REQUEST FOR WAIVER FROM ACCESSIBILITY REQUIREMENTS
OF CHAPTER 553, PART V, FLORIDA STATUTES

Name: LOEWS MIAMI BEACH HOTEL / POOL CABANAS

Re: Loews Miami Beach permit application #B1103686
Request for Waiver from Accessibility Requirements

LS-1

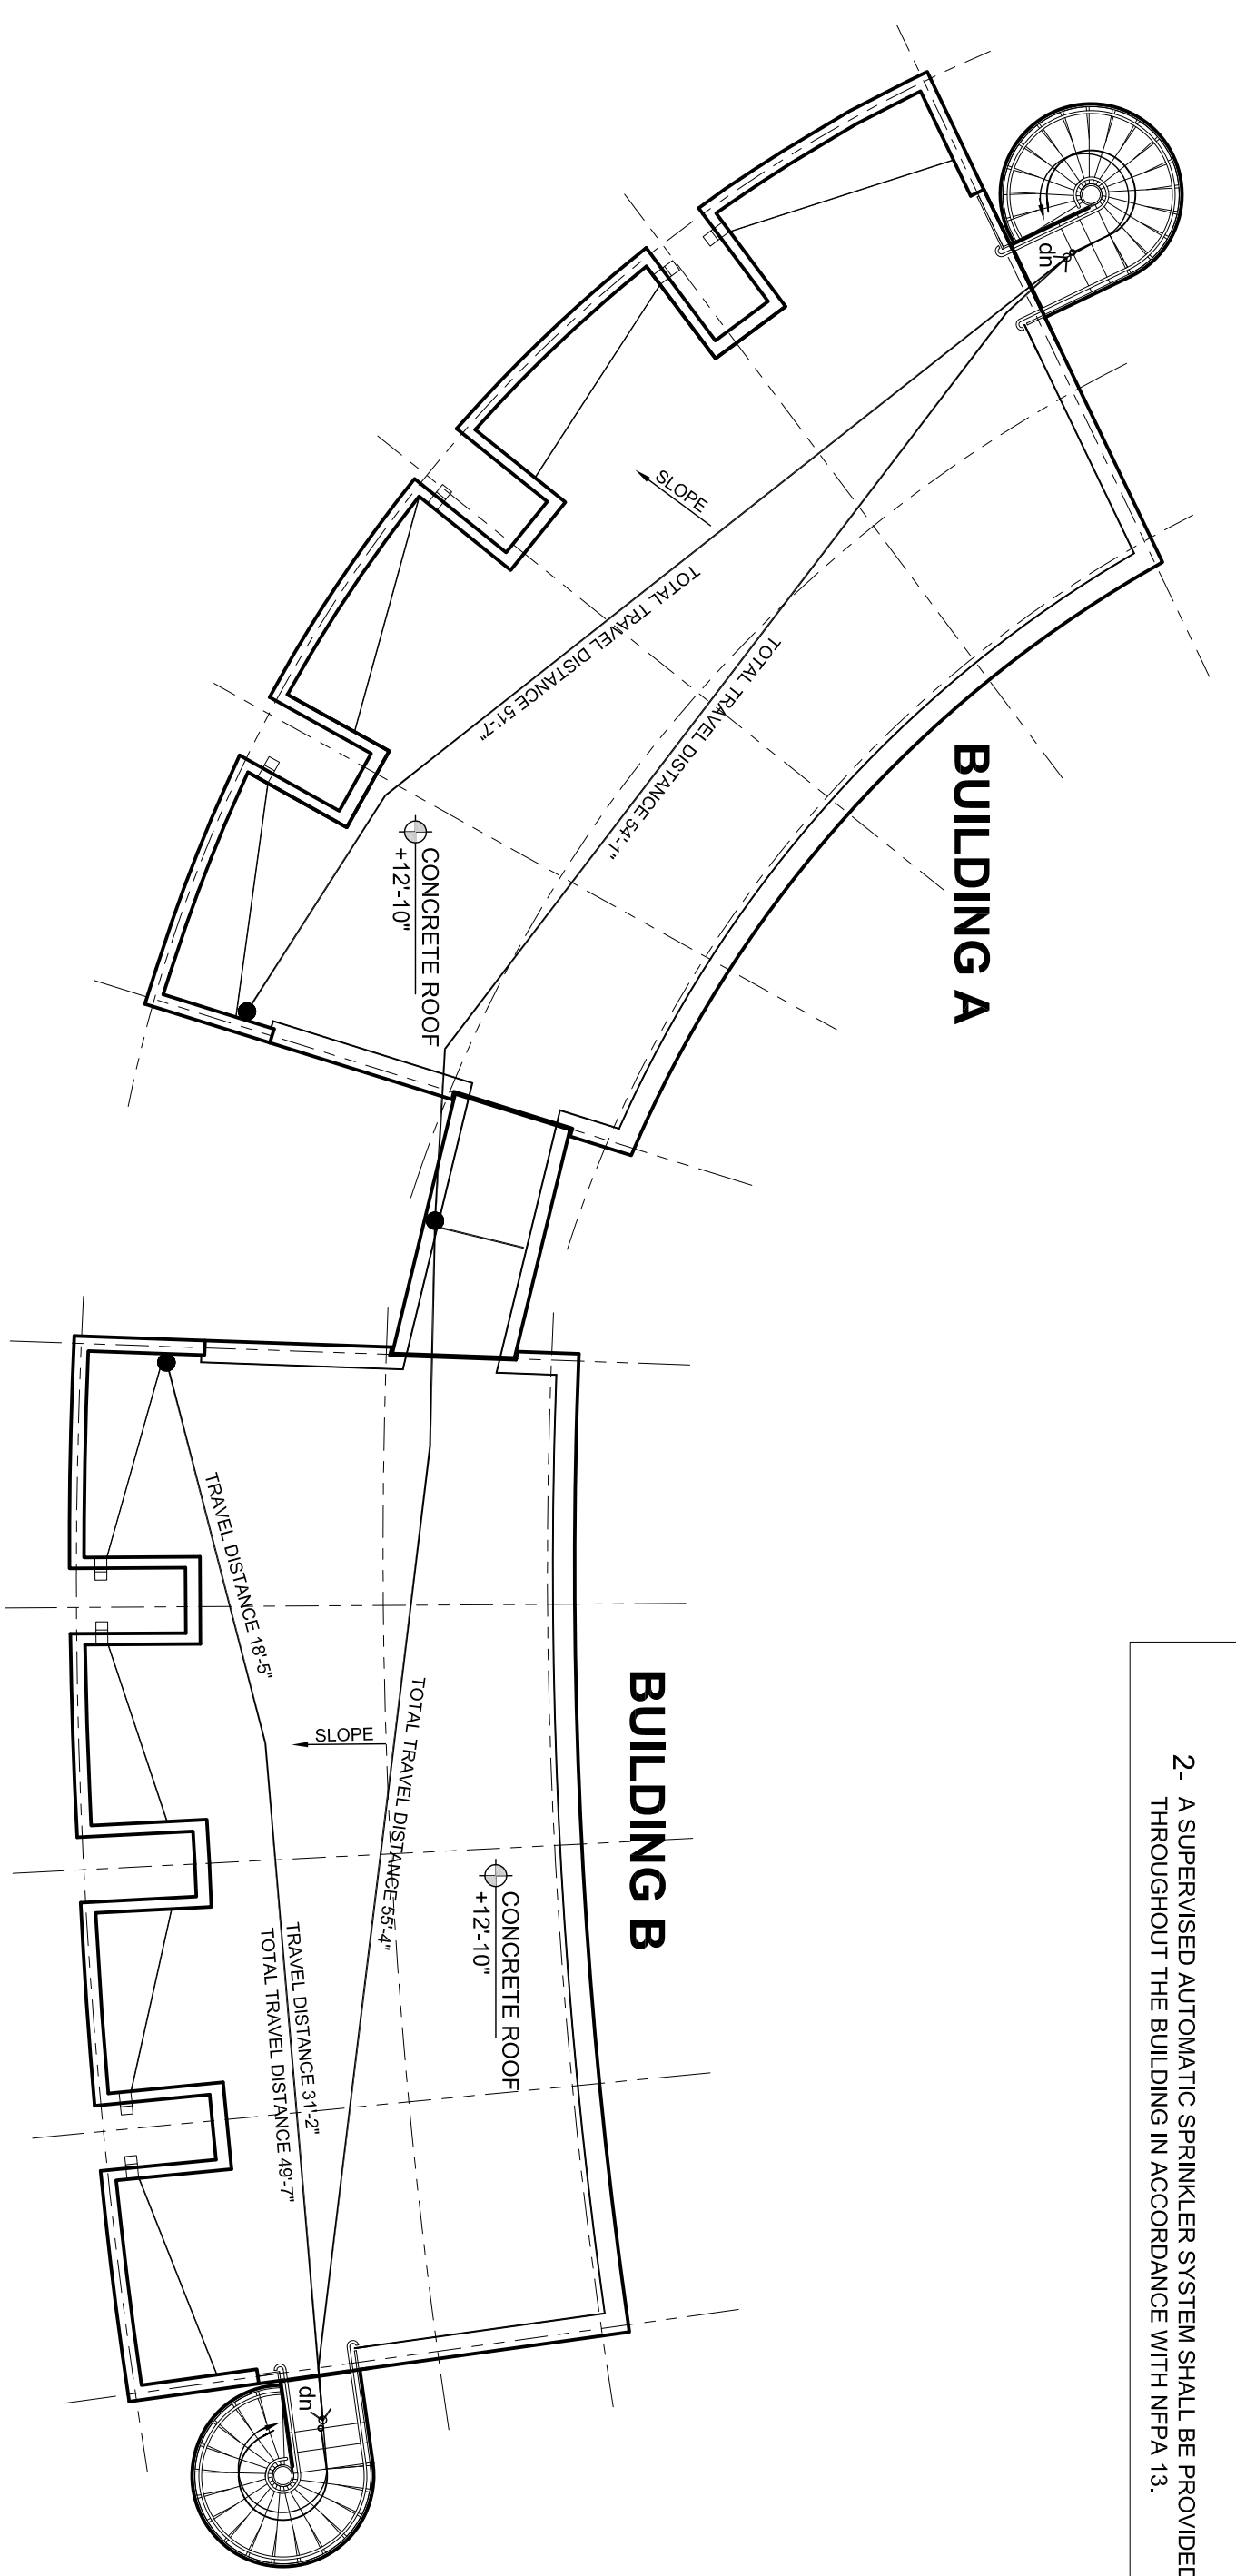
The roof of the cabanas is simply an open space for guests to use as additional sun deck space, and it is currently designed to be accessed by stairs only. Guests renting a cabana have other options for taking in the sun. The area immediately in front of the cabanas is a private sun deck area for guests renting the cabanas as is the sundeck space on the next lower level. These areas are at ground level and are fully accessible to guests with disabilities. Additionally, there is an elevated sun deck area on the roof of the Loews' spa building, which is immediately adjacent to the proposed cabanas and is accessible by elevator. Thus, in the event that a guest with a mobility impairment would like to use a 'rooftop sun deck', the Loews offers accessible facilities which are in close proximity to the cabanas, actually this location is directly across from the cabanas about 20 feet away from cabana #1.

In addition to the above, we believe that the code does not require a building of our size (1,462 s.f) to have accesses to this level. FBC 11-4.1.3 (5) Exception 1 states that an elevator does not have to be provided if the building has less than three stories or is less than 3,000 square feet per floor. Our local building department is also in agreement with us under this provision, and their recommendation is part of this application.

Comments/Recommendation: During review we request compliance with vertical accessibility to all levels. We recommend that the waiver be issue since the building has less than three stories and the area is less than 3,000 square feet per floor; as per FBC 11-4.1.3(5) exception 1 an elevator do not have to be provided if the building has less than three stories or less than 3,000 sq ft per floor.
